URBAN RENEWAL AGENCY MEETING PACKET

A. Hwy 99 Pedestrian Bridge Project (Craig Sheldon, Public Works Director)

Sherwood 99W Pedestrian Bridge Crossing Value Engineering Work Session City Council

Meeting Objective

VE Option #1: Railing Materials

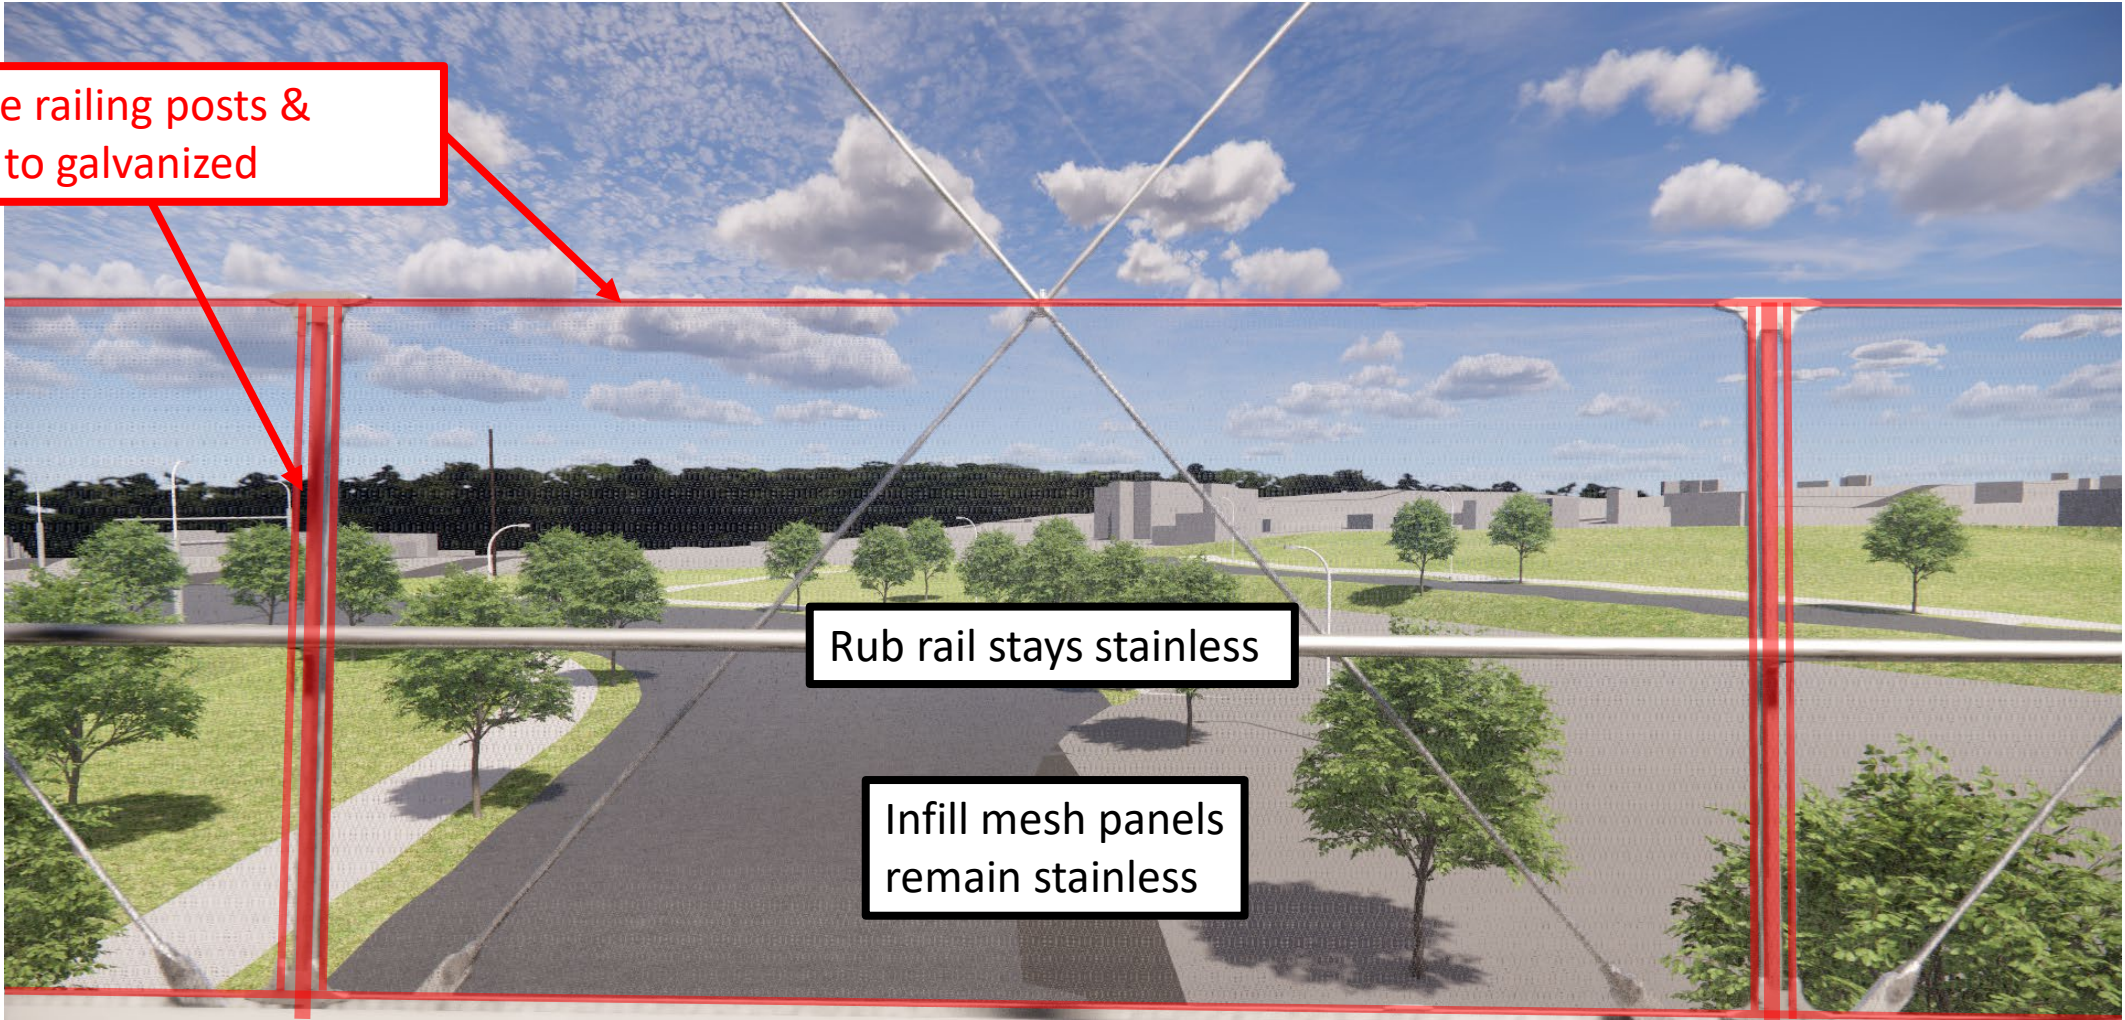
- A. Revise most stainless-steel (SS) components to galvanized**
- B. Keep current railing design/geometry
- C. Keep SS fabric mesh

Approx. **\$600 k to \$800 k** Savings

Current Railing Design + Alternative Material Changes

Change railing posts &
frame to galvanized

Rub rail stays stainless

Infill mesh panels
remain stainless

VE Option #2: Lighting & Railing Redesign

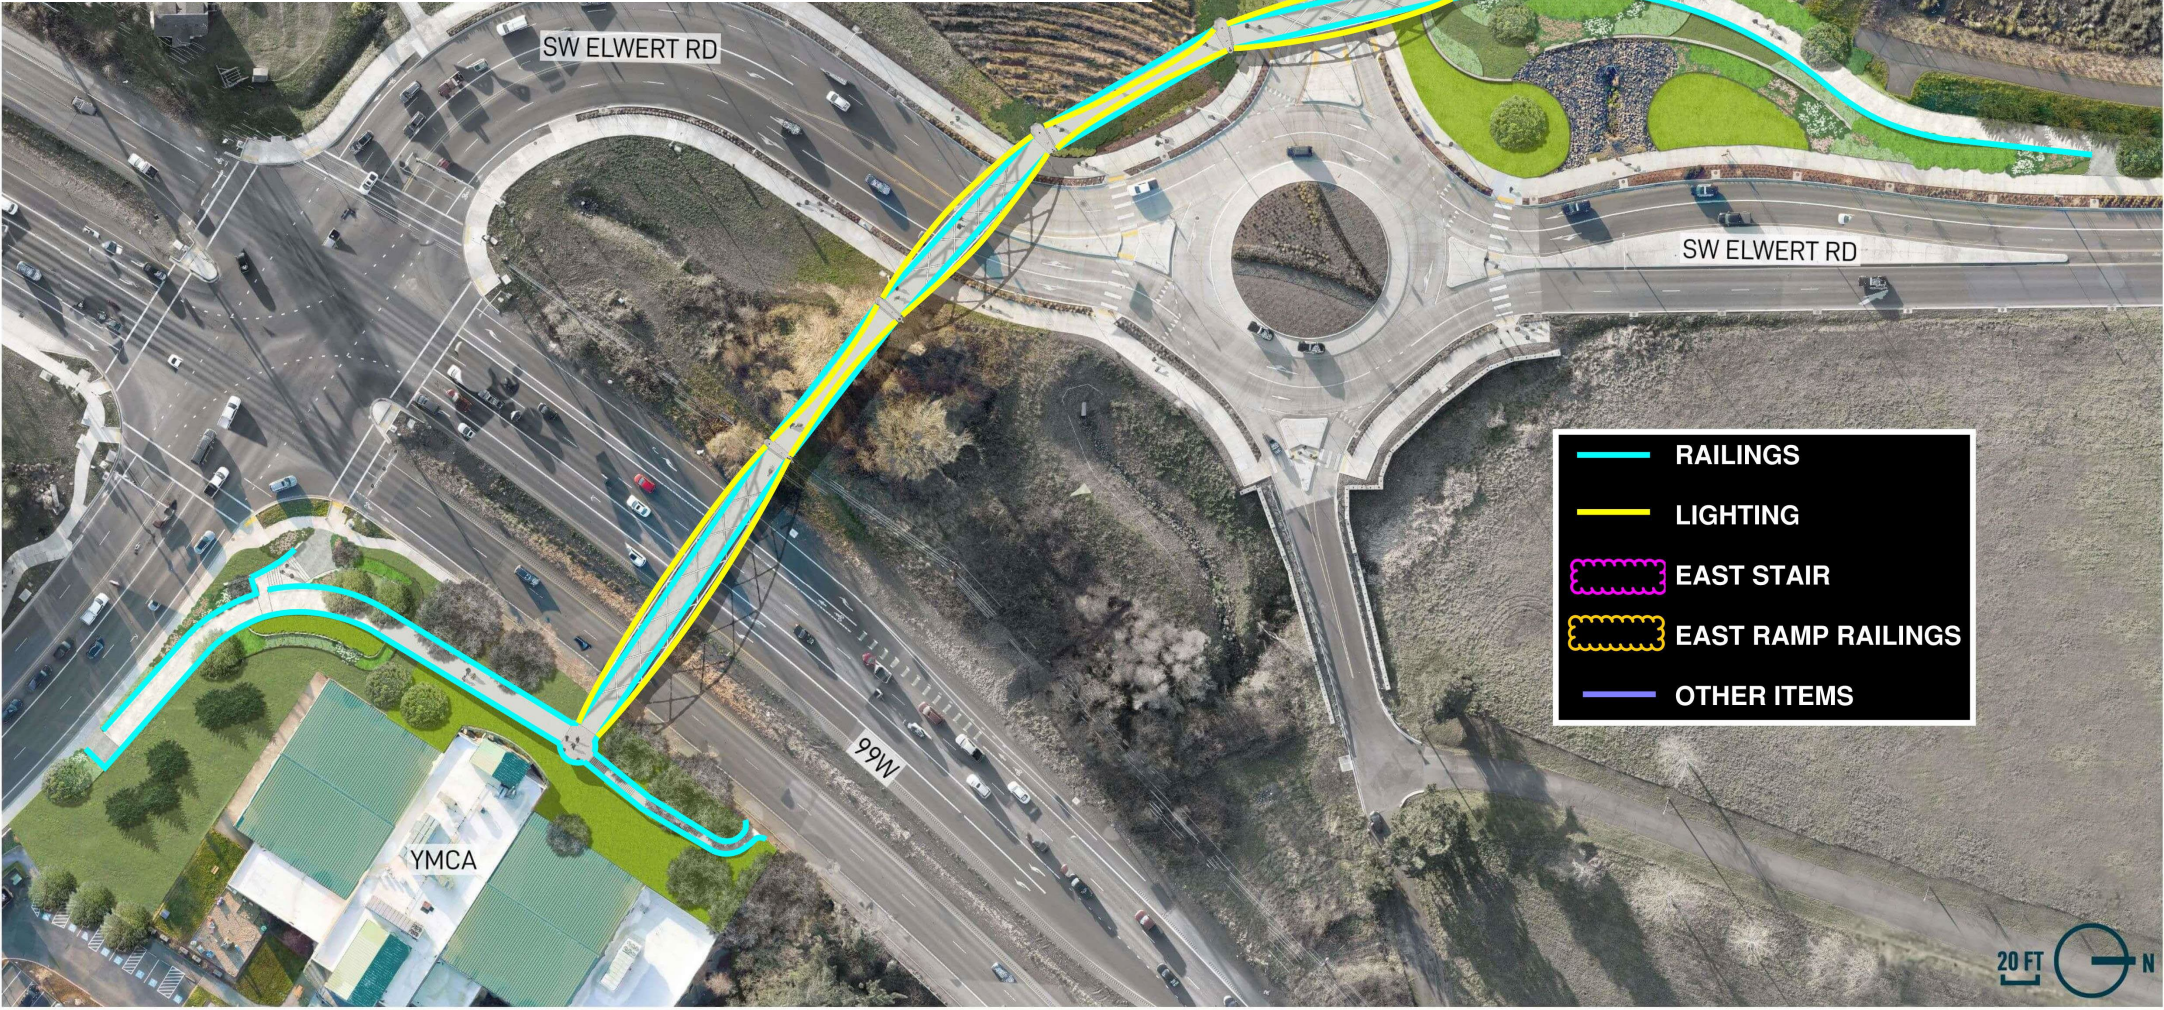
- A. Lighting:** Replace illuminated railings with poles for pathways
- B. Lighting:** Replace architectural arch up/downlights with LED strip
- C. Railings:** Full redesign
 - I. Stainless steel to galvanized (sim. to VE #1)
 - II. SS cable mesh to galvanized welded wire mesh
 - III. Reduce deck clear width
 - 14'-0" to 13'-8" typical, 13'-4" to 11'-6" at ends of arches

Approx. **\$3.0 M to \$4.5 M** Savings

Pathway / Deck Lighting

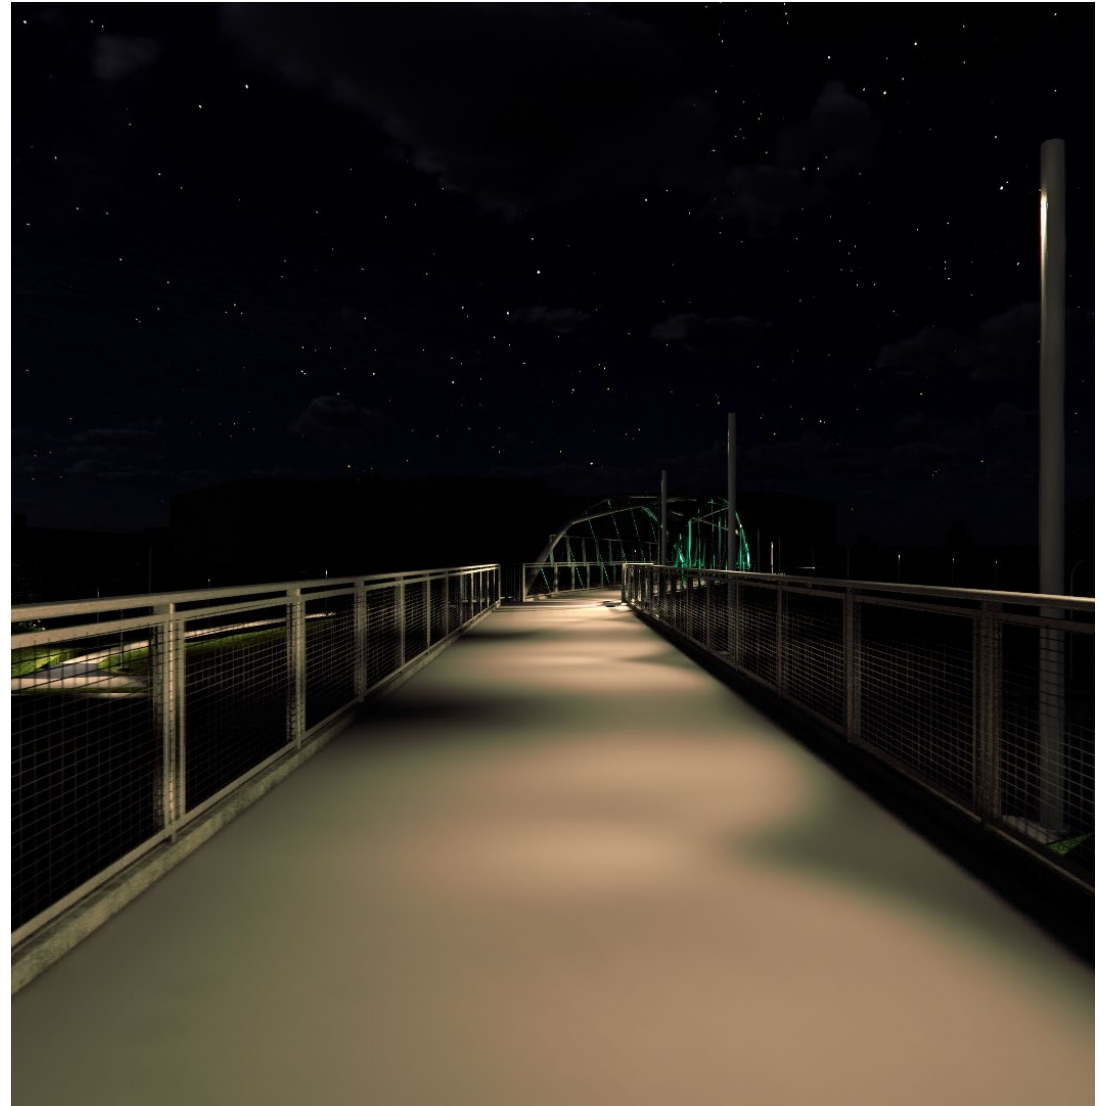
Current – Handrail-integrated Deck Lighting

Alternative – Same poles used at walkways and belvederes

Deck Lighting with All Poles

Architectural / Arch Lighting

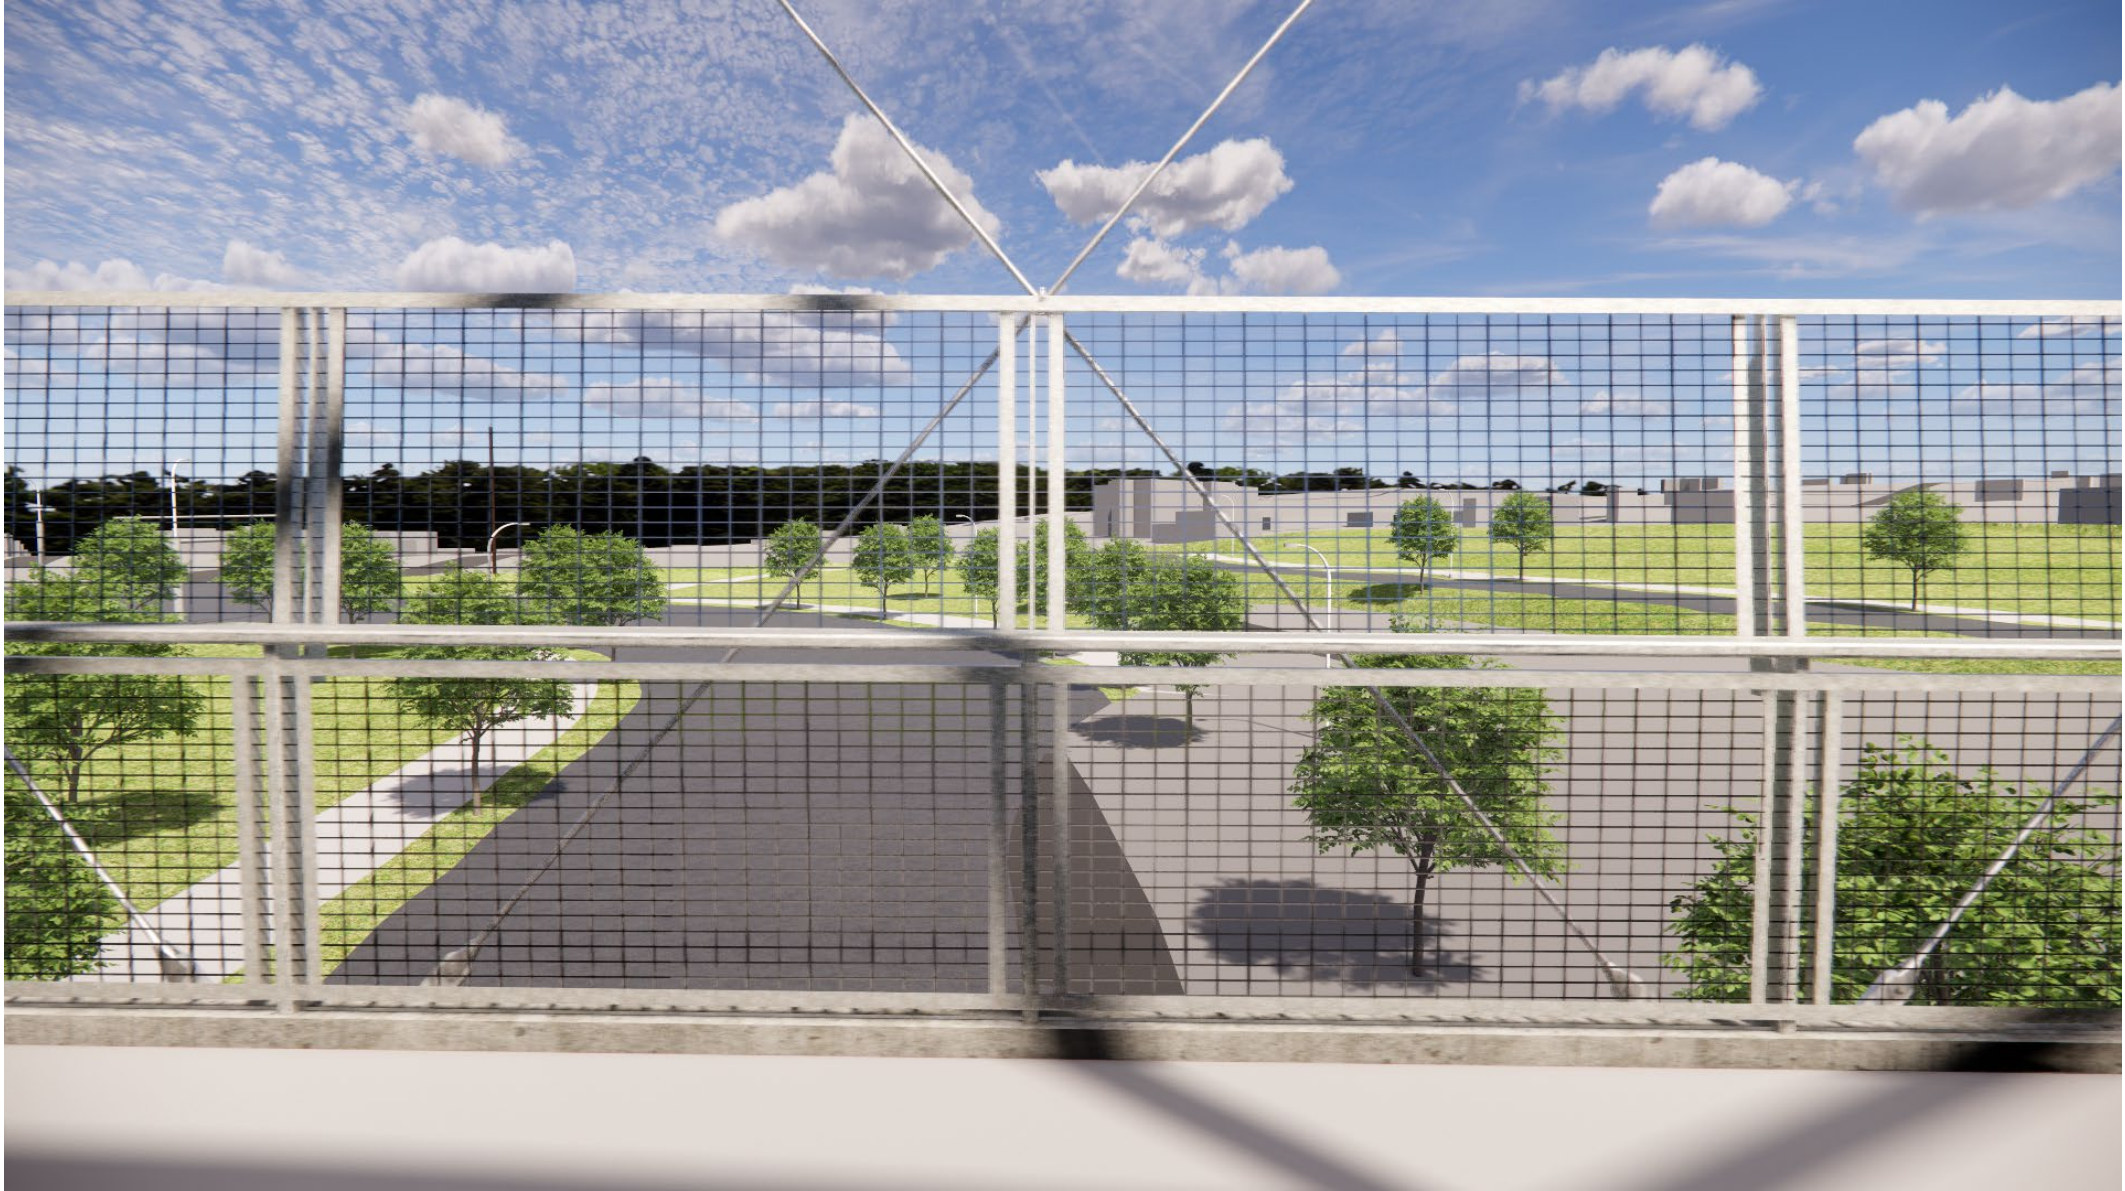
Current – Colored Uplighting throwing light onto the arches

Alternative – Colored Strip Lighting emitting light from the arches

Railing Design – SS Fabric vs. Galvanized Mesh

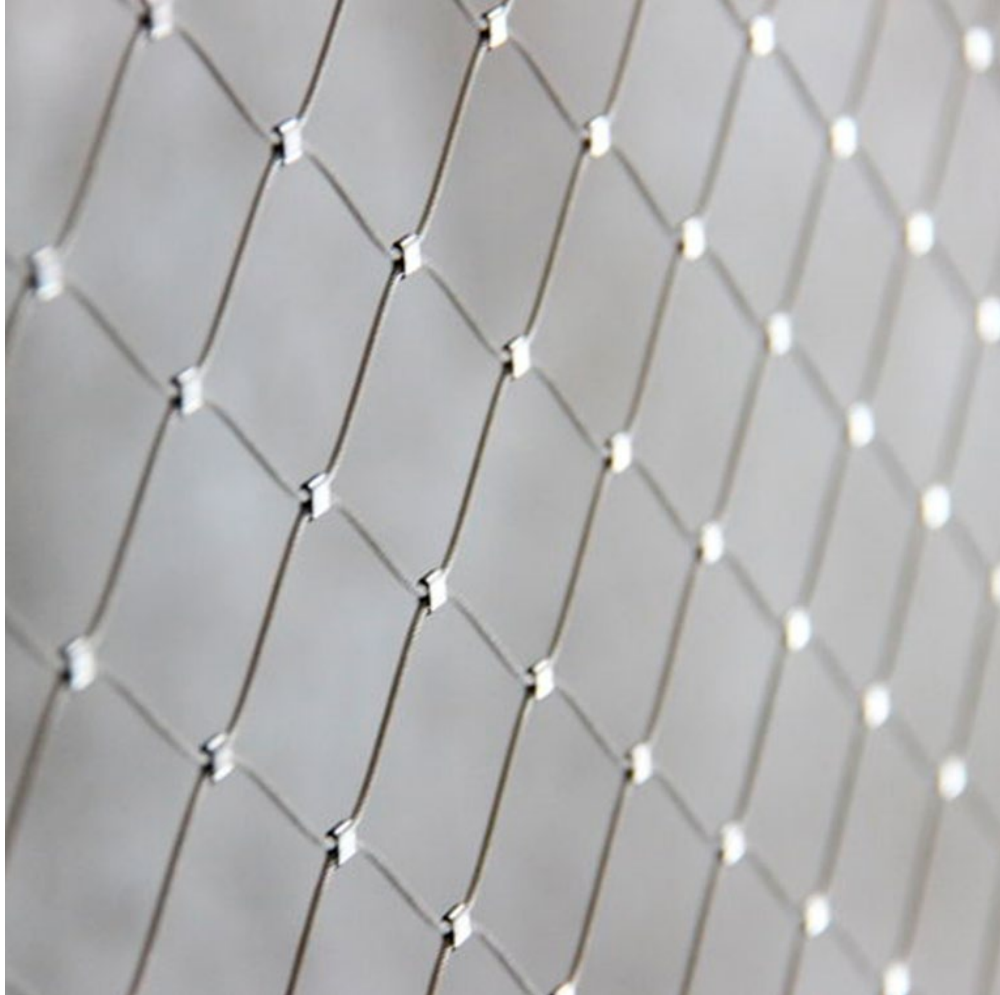
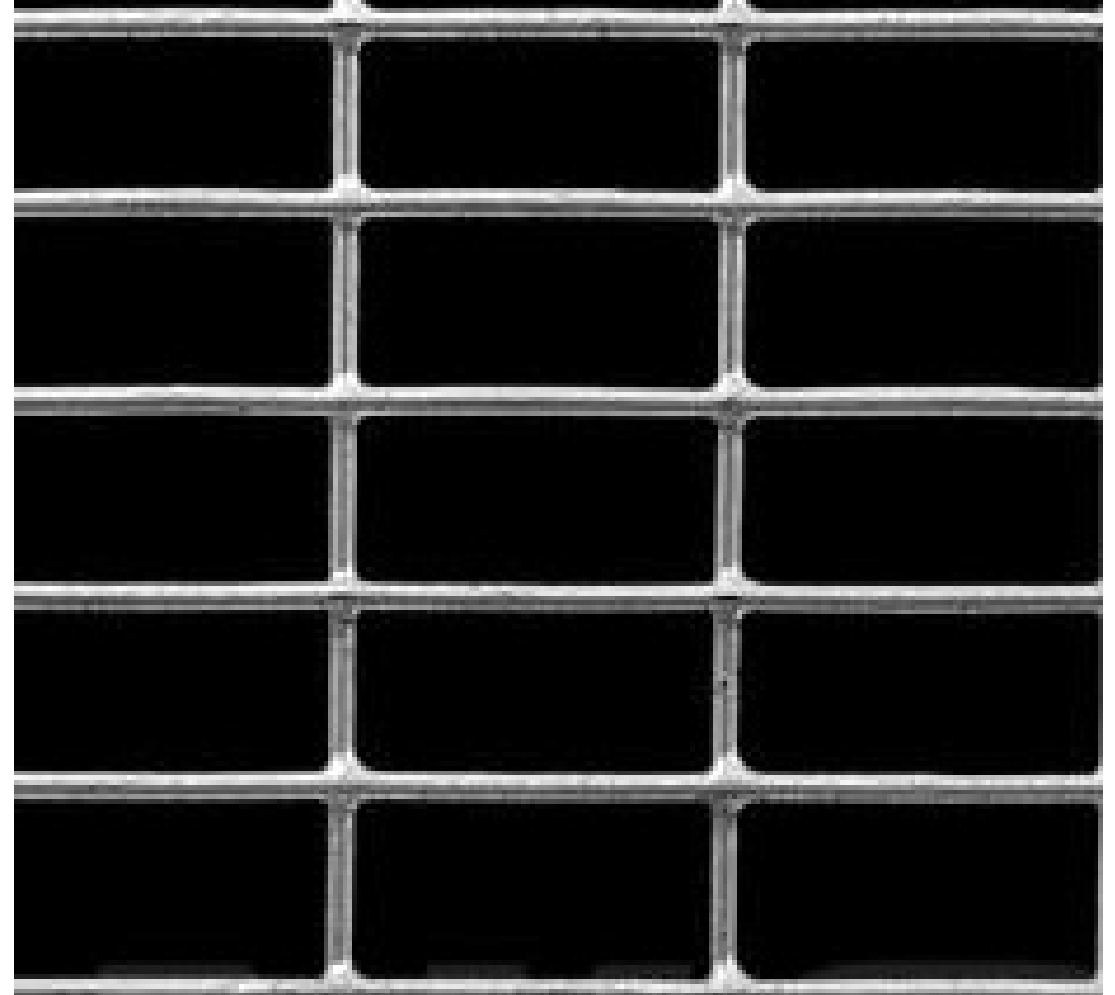
Current Design

VE Option #2
